CONSOLIDATED EDISON COMPANY
OF NEW YORK, INC.

(Indian Point Station, Unit No. 2)

Evaluation of Modifications
to
Steam Generator Support Shoes
and
Reactor Vessel Support Ring
at
Indian Point Generating Station
Unit No. 2

STRUCTURAL EFFECT OF MODIFICATIONS
TO
STEAM GENERATOR SHOES

MODIFICATION #2 (PAGES 6 & 7) BASE PLATE CUTBACK

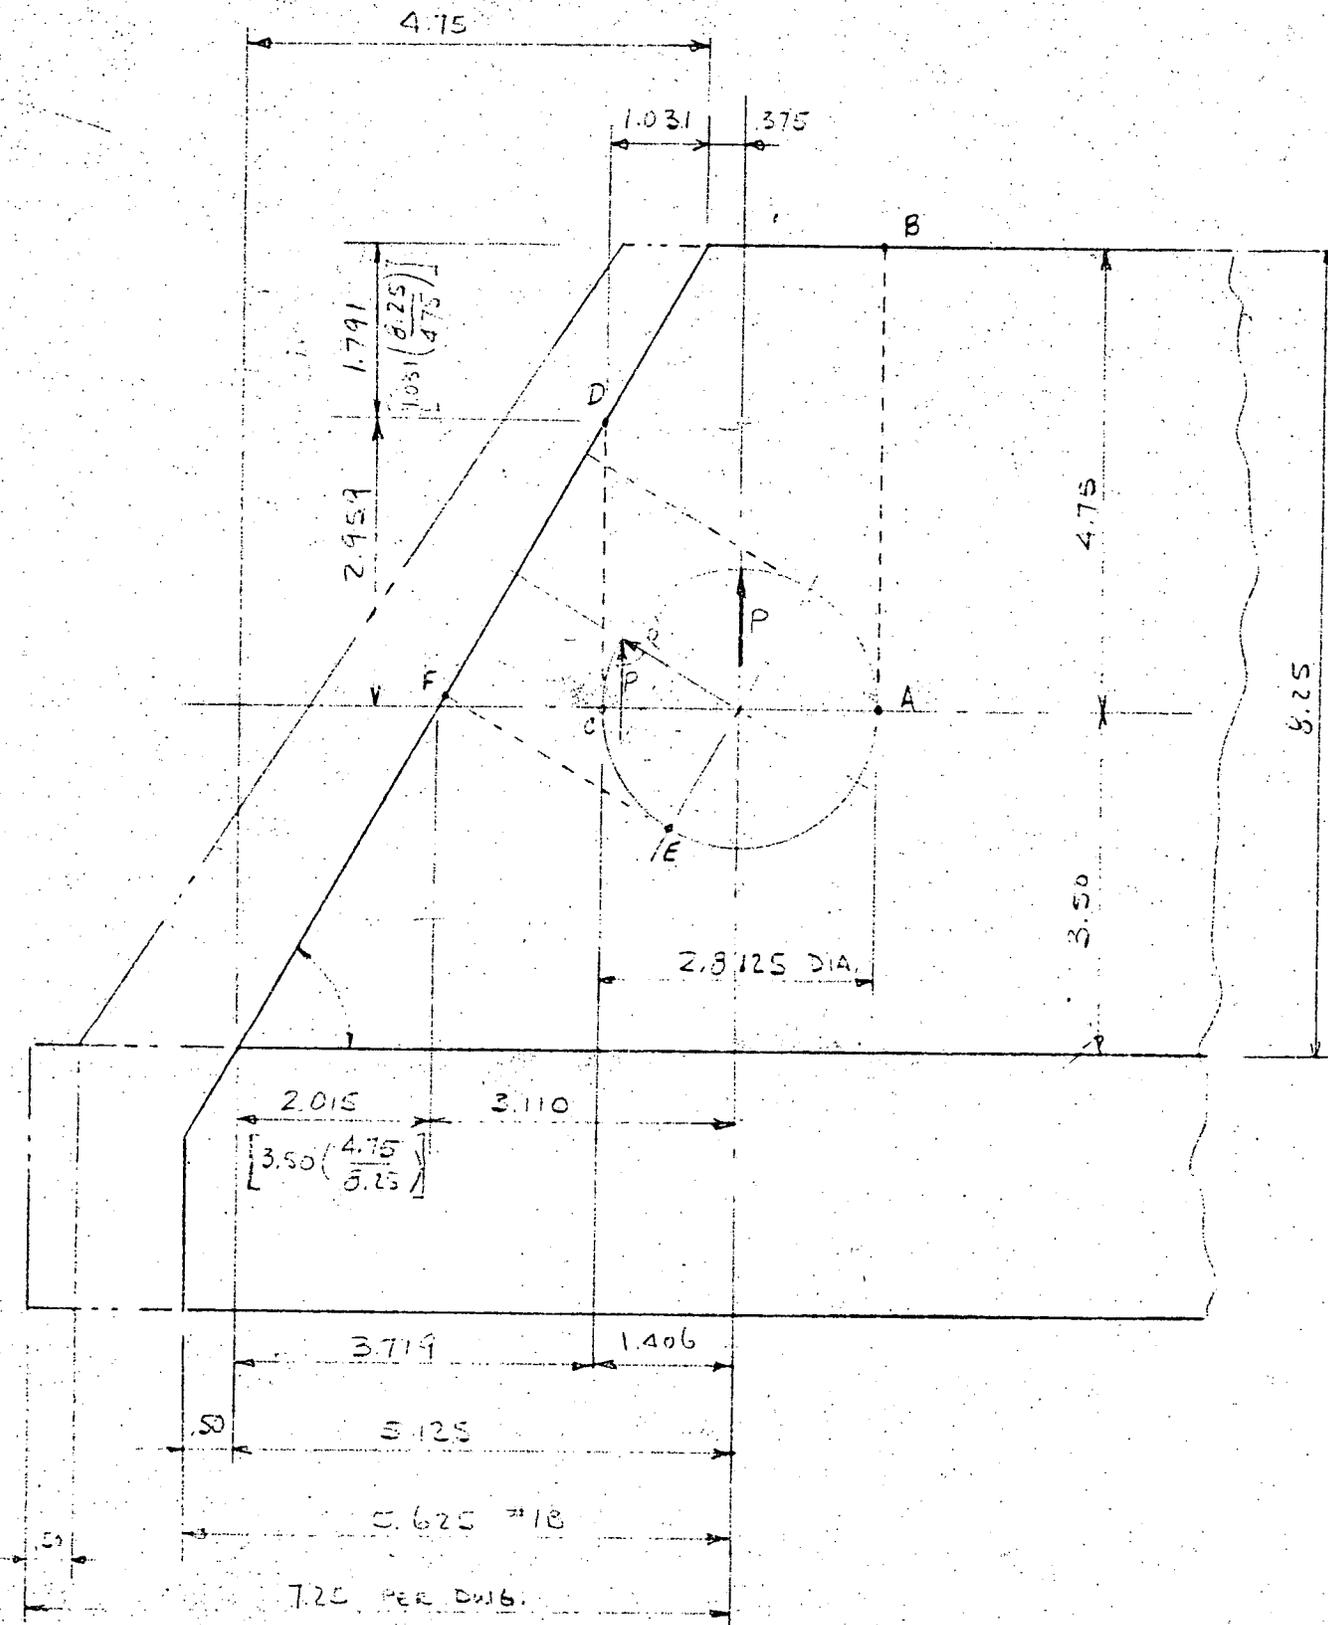
WELD AREA, AS CUT-BACK, EXCEEDS MIN. GUSSET CROSS-SECTIONAL AREA THROUGH PINHOLE, AND SO IS NOT LIMITING. CONSERVATIVELY CALCULATED STRESS AT MIN. AREA TRU PINHOLE IS $33297 \text{ PSI} < S_{\text{allow}} = 0.45F_y = 40000 \text{ PSI}$.

OTHER BASE PLATE CUT-BACKS ARE CORNER & EDGE MITRES OF NON-LOAD-CARRYING MATERIAL.

MODIFICATION #1 - CUTBACK ON GUSSET

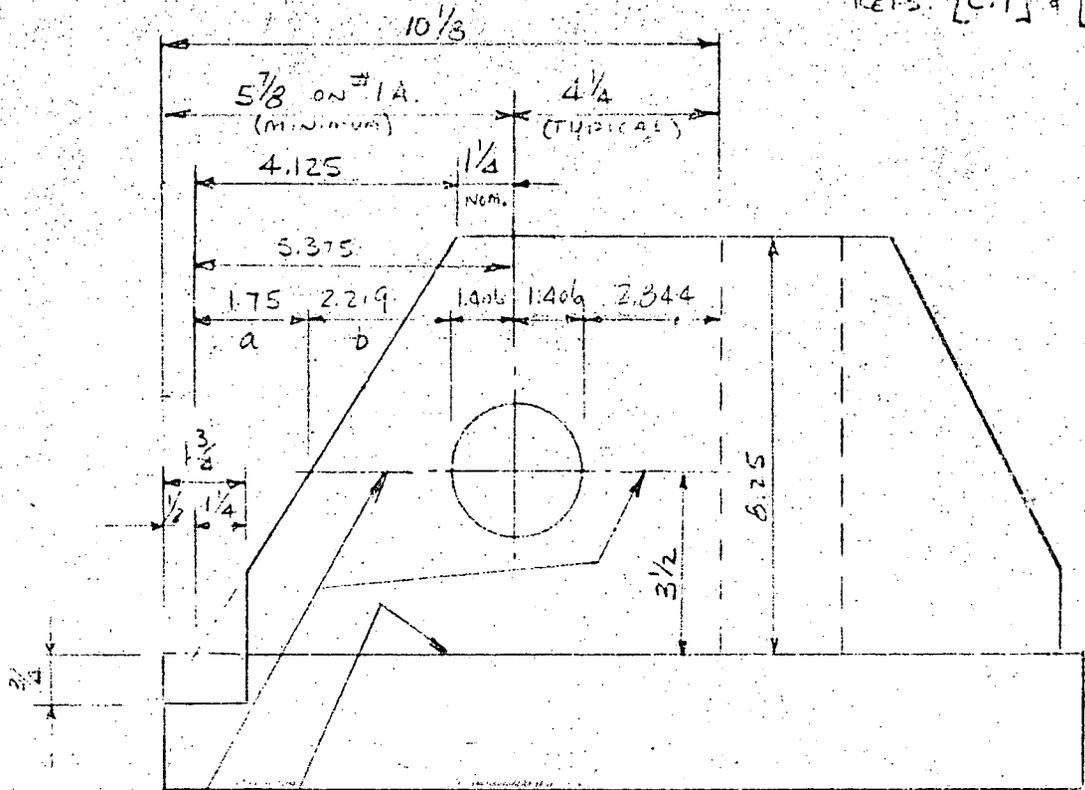
USING THE MINIMUM EDGE DISTANCE \overline{EF} AND COMPONENT OF LOAD IN THAT DIRECTION, P' :

$$P' = \frac{4.75}{\left[(4.75)^2 + (3.25)^2 \right]^{1/2}} P = \frac{4.75}{9.520} P = .50 P = 463.5 \text{ K}$$

$$\overline{EF} = 3.110 \frac{3.25}{9.520} = 2.695$$

MODIFICATION #2 - CORNER BEVELS ON BASE PLATE

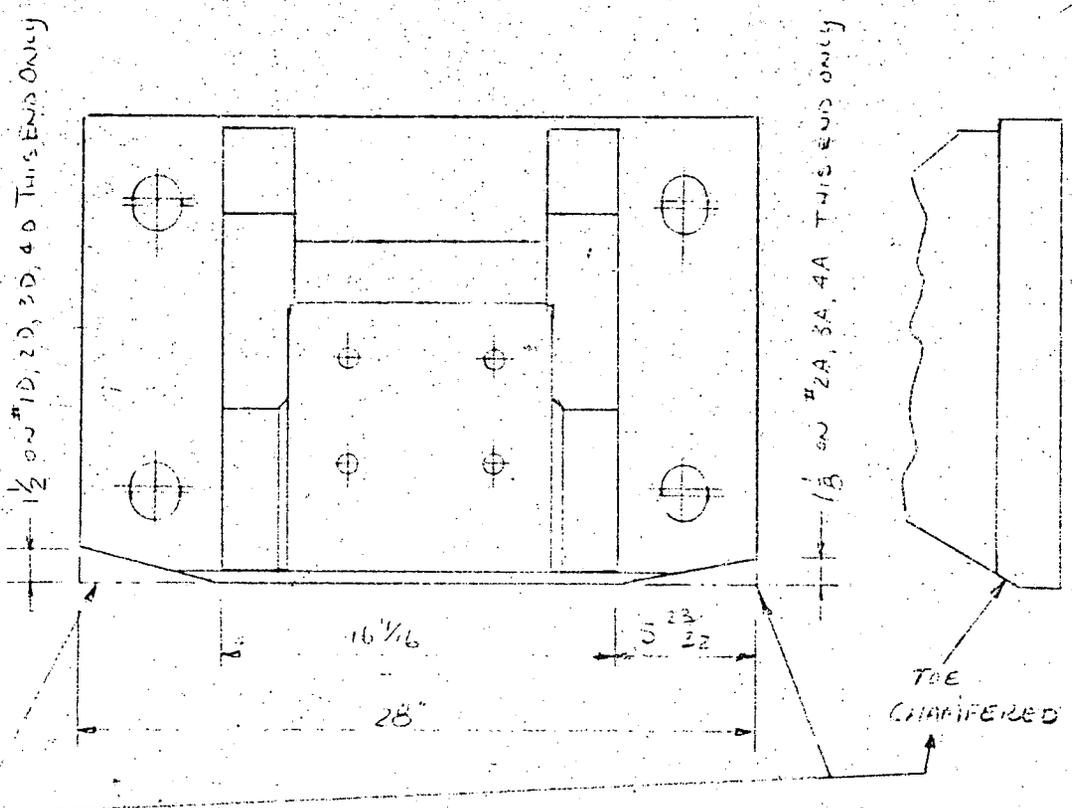
MATERIAL REMOVED HERE AT THE CORNERS IS NON-LOAD CARRYING MATERIAL. STRENGTH OF SHEET IS UN-AFFECTED.

REF. [A.2]

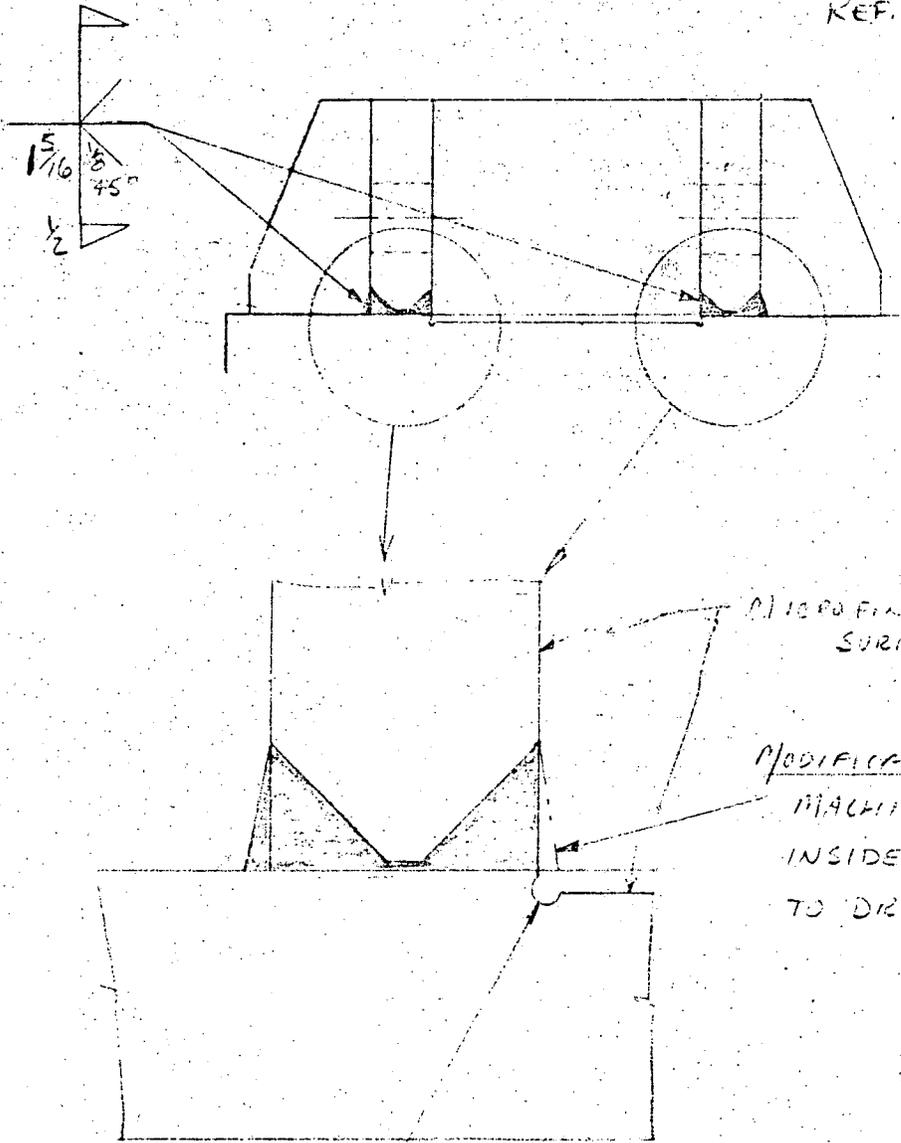
MODIFICATION #3

THIS MODIFICATION BRINGS THE PART TO DRAWING,
AND THEREFORE HAD NO EFFECT ON THE AS-DESIGNED
SHOE STRENGTH.

REF DRG [B.5, C.2, A.4]

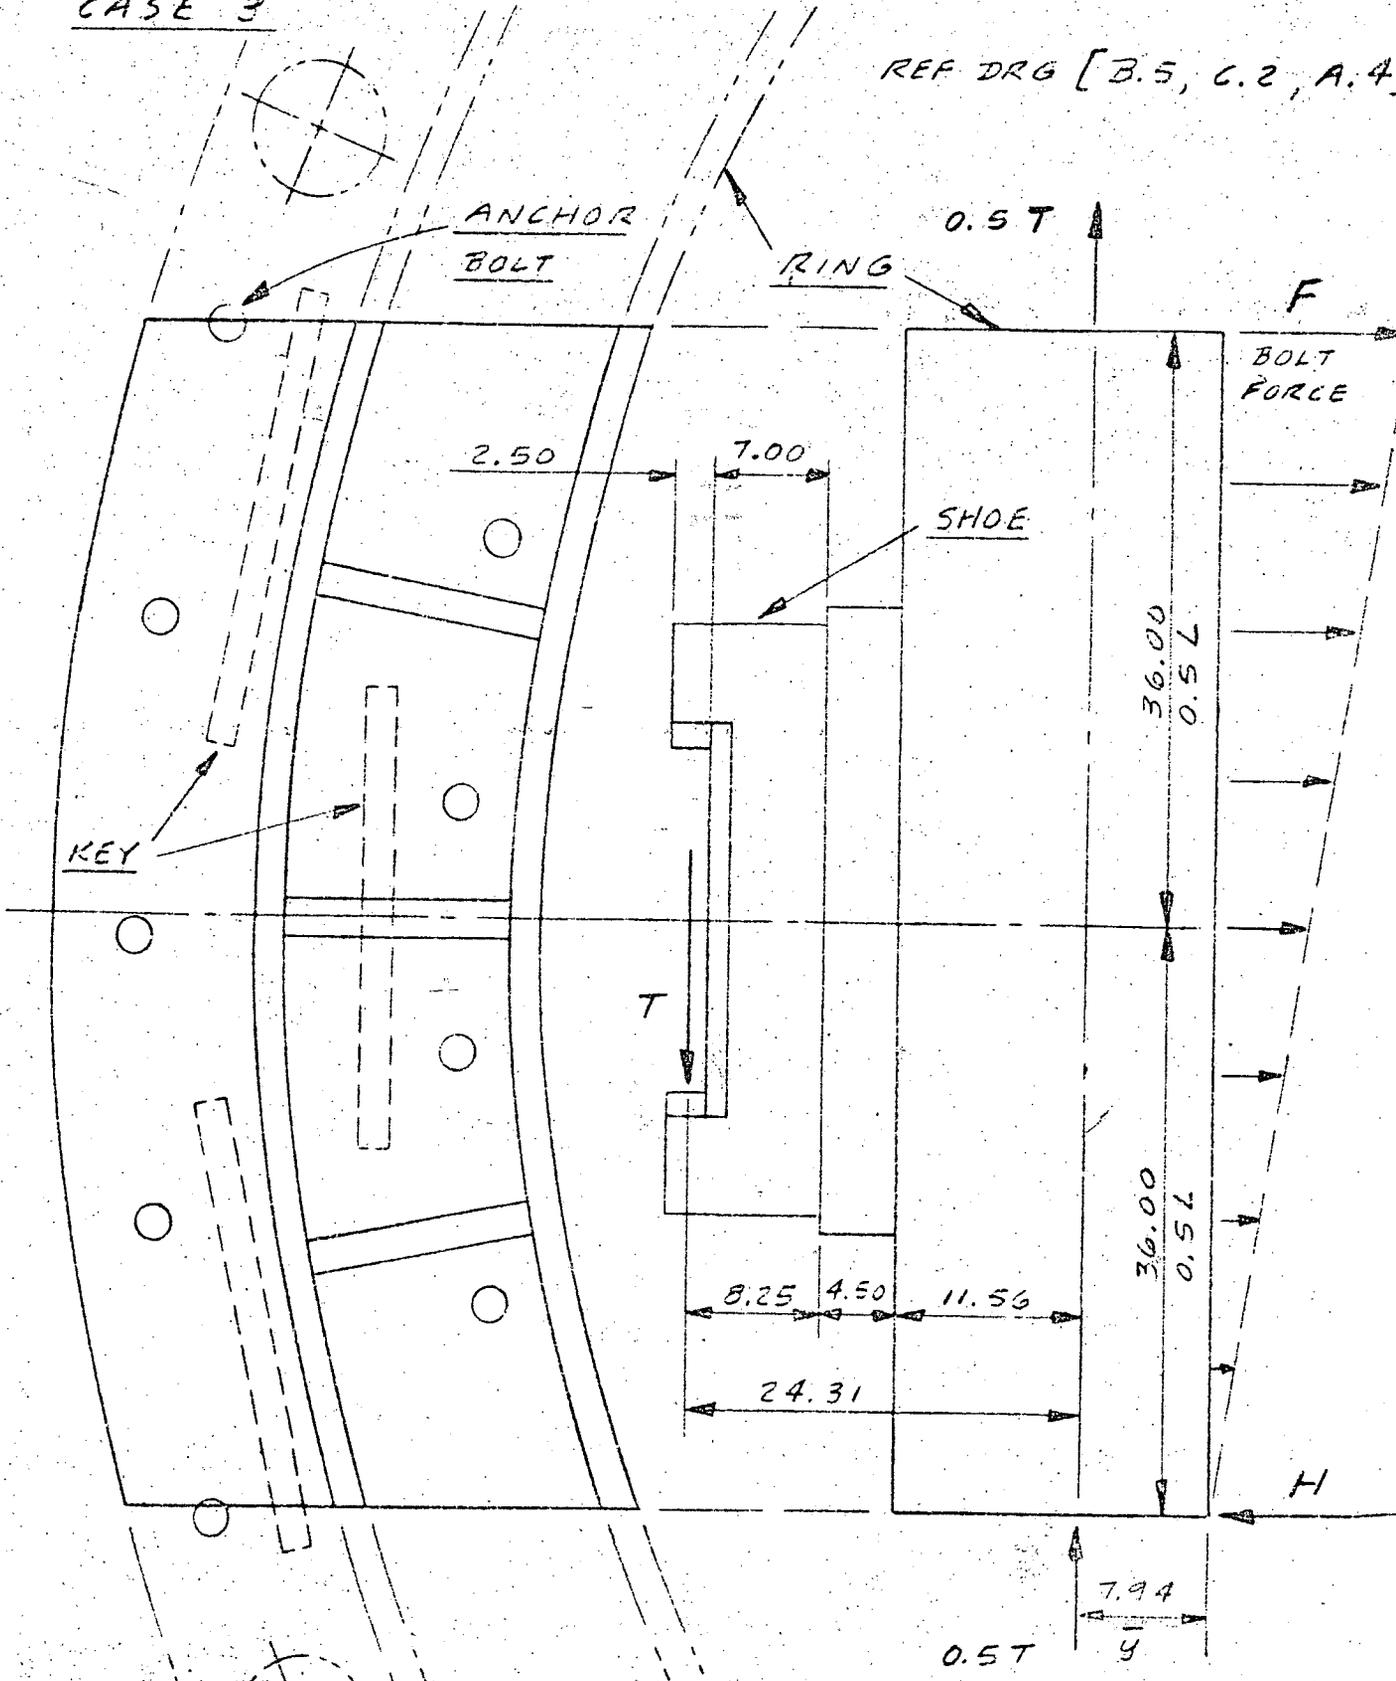
STRESSES CAUSED BY TANGENTIAL FORCE T
CASE 3

STRESSES CAUSED BY VERTICAL FORCE "P"
CASE 4

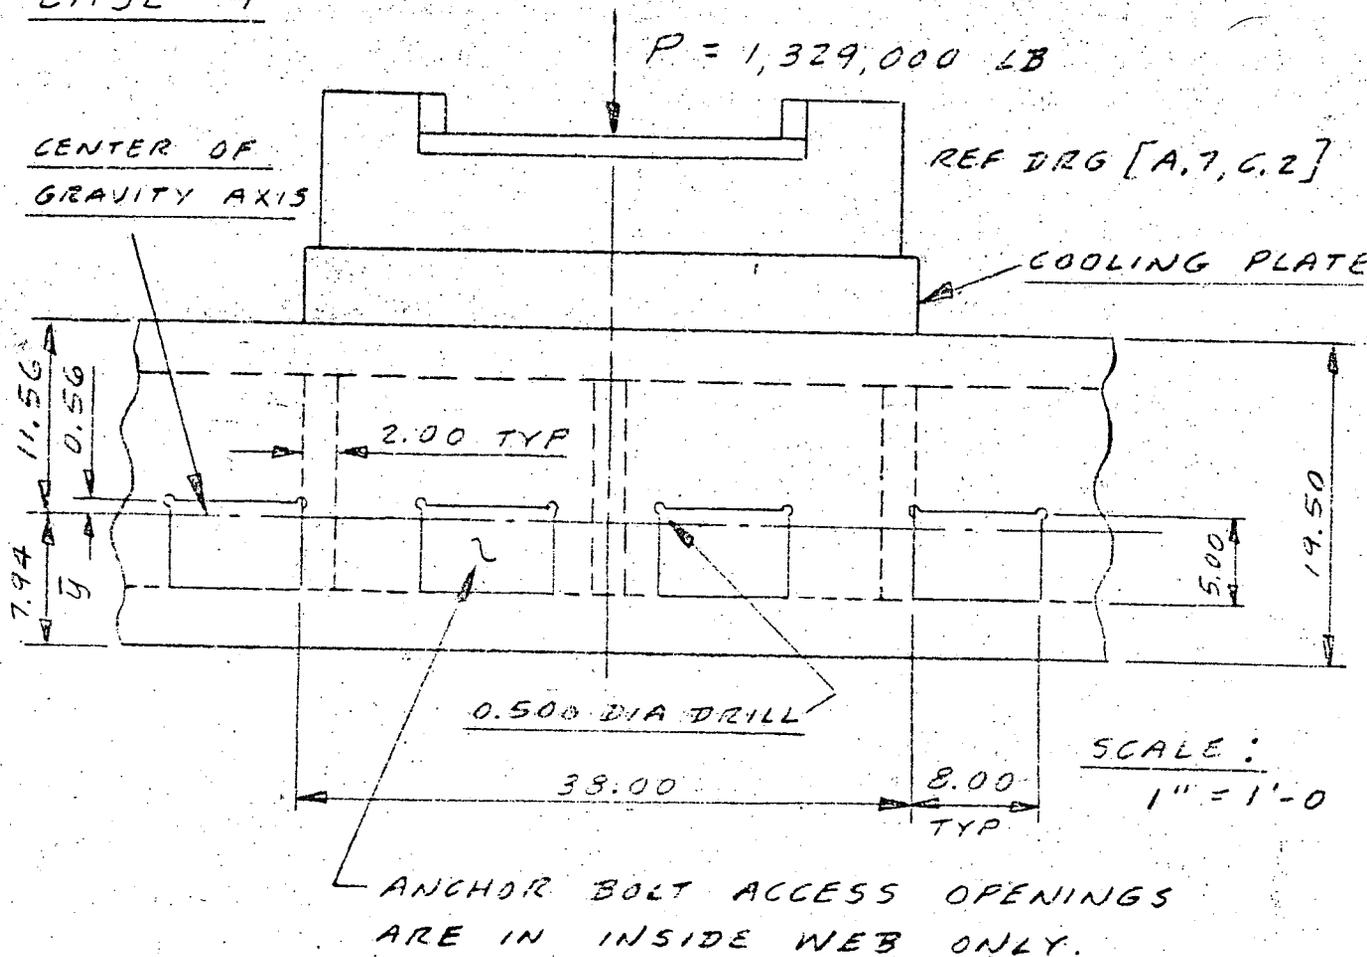
$$\begin{aligned} \sigma_c &= \text{BEARING STRESS OF CONCRETE} \\ &= \frac{1,329,000}{38.00 \times 18.00} = \underline{1943 \text{ PSI}} < 3000 \\ &\text{OK} \end{aligned}$$

$$\begin{aligned} \sigma_s &= \text{COMPRESSIVE STRESS OF STEEL} \\ &= \frac{1,329,000}{(2.00)[(14.00 \times 3) + (38.00) + (38.00 - 16.00)]} \\ &= \underline{6515 \text{ PSI}} \end{aligned}$$

NOTE : THE FLAME CUT OPENINGS WERE MODIFIED BY DRILLING AS SHOWN.

STRESS CAUSED AT TOP OF ANCHOR BOET
ACCESS OPENINGS BY RADIAL FORCE R
AND TANGENTIAL FORCE T.

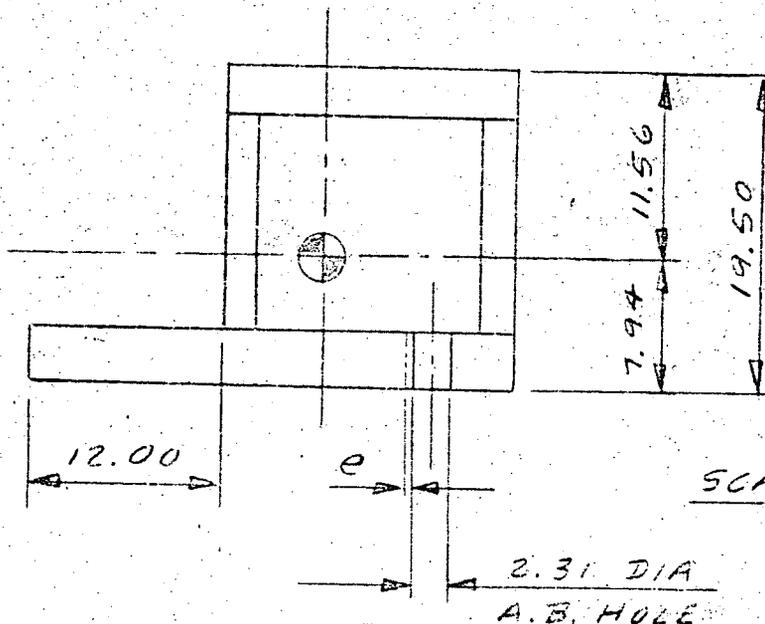
REFER TO SKETCH ON PRECEDING PAGE
AND TO STRESS RESULTS ON PAGES
12, 14 AND 19.

THE 2.31 DIA HOLE IS SPECIFIED BY THE DRAWING. ELONGATION e , WHICH IS DRAWN TO SCALE, PICTORIALIZES THE WORST CONDITION.
